Appl. No. 10/673,006
Amdt. Dated August 19, 2005
Reply to Office Action of May 19, 2005

Amendments to the Drawings:

Please amend drawing sheets 1-3, FIGS. 1, 2A and 3 as depicted in the attached
“Replacement Sheets” and “Amended Sheets.”

FIG. 1

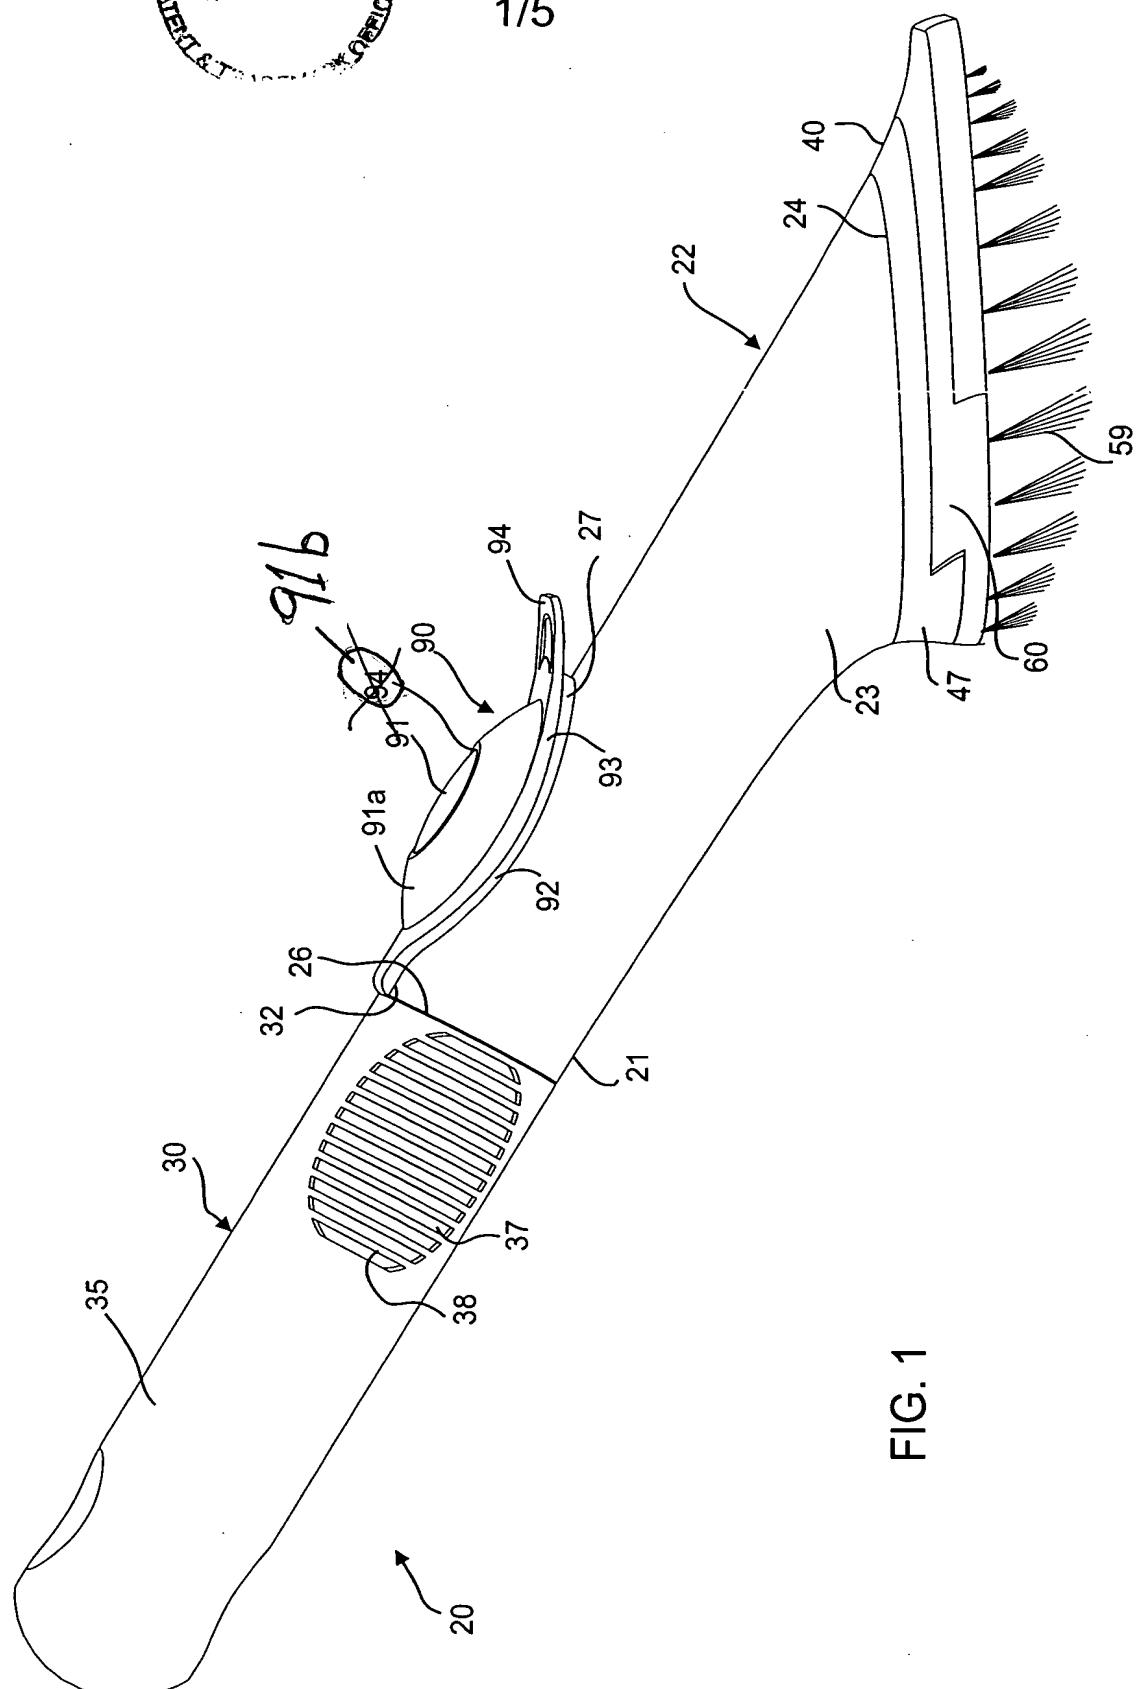
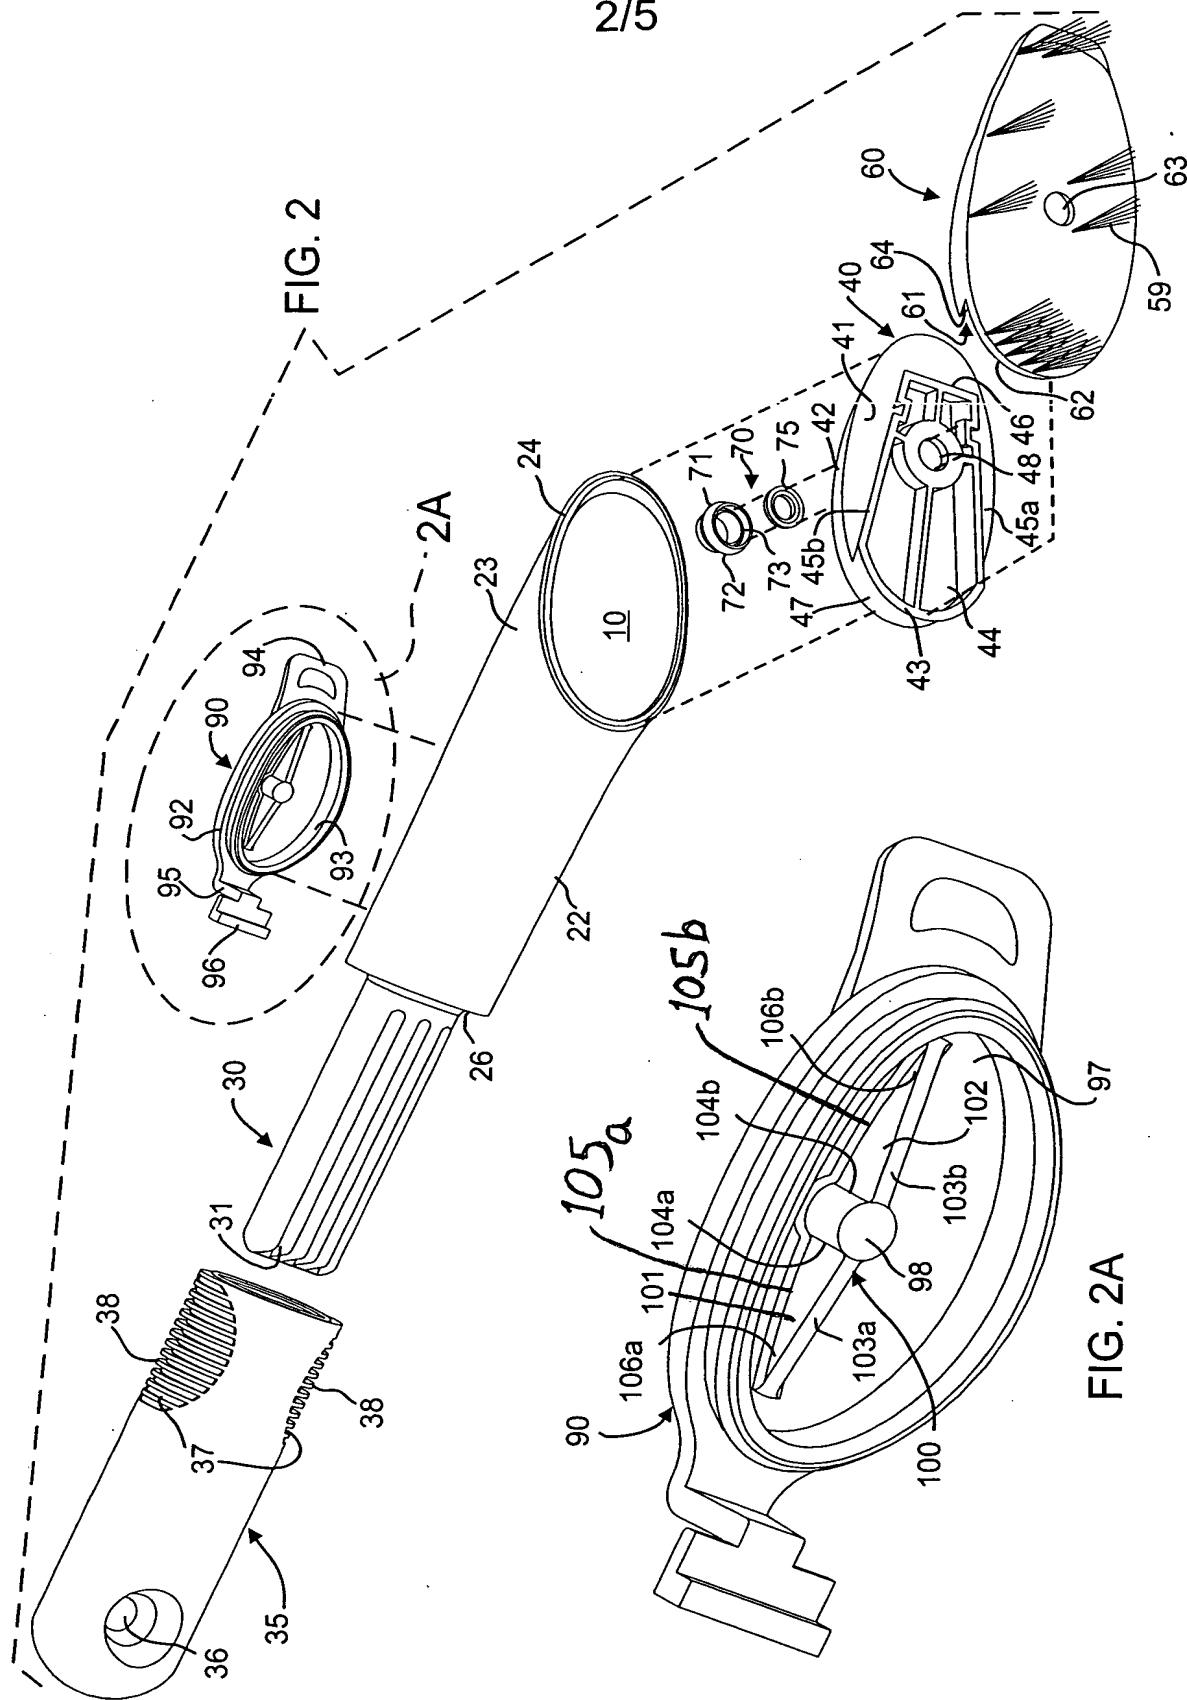
The drawings were objected to with respect to reference numbers 49, 105a/105b, 126 and 101. Applicant has amended the specification and the drawings in order to overcome these objections. The enclosed drawing sheets are submitted in order to correct these errors. Applicant has provided both Replacement Sheets and Amended Sheets showing the changes to FIGS. 1, 2A and 3.
